TOLEDO - LUCAS COUNTY PLAN COMMISSIONS

REF: SUP-6007-22

SUBJECT: Special Use Permit for day care center at 3104 Nebraska

PROPOSED SITE PLAN

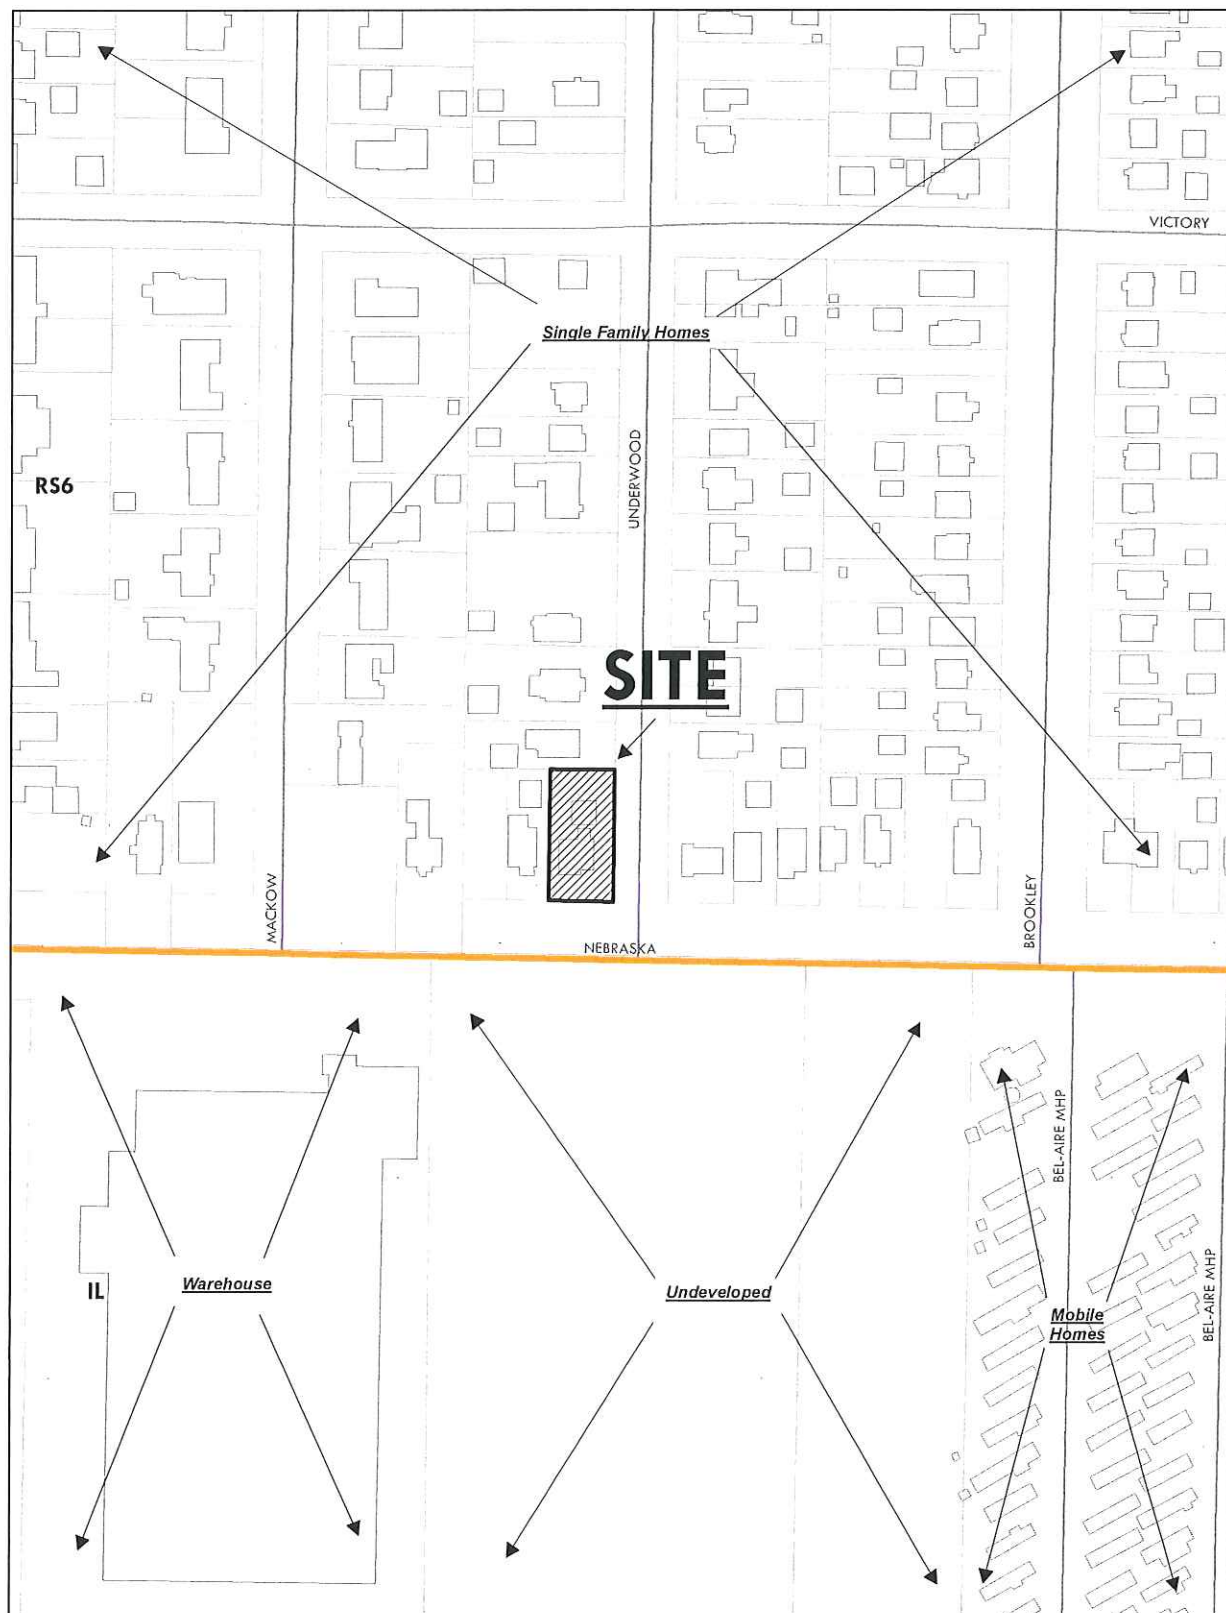
8. Thirty-five (35) square feet of useable indoor space per person in care must be regularly available for the day care operation. **Acceptable as depicted on site plan. The site plan submitted depicts an occupancy area of 1,510 square feet.**

9. Sixty (60) square feet of useable outdoor space must be provided for each person in care using the outdoor area at any one time. A Type B landscape buffer shall be provided around the outdoor space. **Acceptable as depicted on site plan. However, only nine (9) children shall use the outdoor play area at any one time.**

10. Parking Schedule "A" (TMC§1107.0304) states that Day Care Centers must have one (1) parking space per six (6) person capacity or one (1) space per 400 square feet, whichever is greater. **Acceptable as depicted. Note the applicant shall have no more than twenty-four (24) individuals on site at one time due to parking limitations.**

11. Off-street parking and loading spaces, parking lots, maneuvering areas, aisles and driveways must be surfaced with concrete, bituminous asphalt, or other dust-free material other than gravel or loose fill, and be graded to drain all surface water towards the interior of the parking lot. **Acceptable as depicted on site plan.**

12. Any spaces reserved for the use by persons with physical disabilities shall adhere to the standards outlined in TMC§1107.1700.
13. A minimum of two (2) bicycle parking slots shall be provided pursuant to Off-Street Parking Schedule "A" (TMC§1107.0300). **Shall be depicted on revised site plan.**

- a. A Type "B" Landscape Buffer is required around the outdoor play area. The buffer shall be a minimum of ten feet (10') in width with ten (10) trees and either fencing or shrubs. The location, height and materials for any fencing to be installed and maintained shall be indicated. **Not acceptable as depicted on site plan. One (1) additional tree shall be provided around the play area and depicted on a revised site plan.**

- c. Dumpster location(s) shall be clearly defined, have a concrete pad and be surrounded by a solid wooden fence or masonry screen enclosure with landscaping and shall not be located in any required setbacks or the public right-of-way as stated in TMC§1361.10(b)(10) of the Building Code. **Dumpster enclosure details shall be provided on a revised site plan.**

- f. The location, number, height, diameter and species of any materials to be planted and maintained, as well as the location and number of any existing trees to be retained; **not acceptable as depicted, all species and location of shrubs shall be identified on a revised landscape plan.**

- g. The location, height and materials for any fencing to be installed and maintained; Pursuant to TMC§1105.0302(A)(1), fences may not exceed 3½ feet in height in the required front setback. Additionally, per TMC§1105.0303, the use of barbed wire, razor wire, concertina wire or the like shall not be permitted in the front yard setback and not anywhere along a street right-of-way; **not acceptable as depicted, height and fencing material shall be indicated on a revised site plan,**
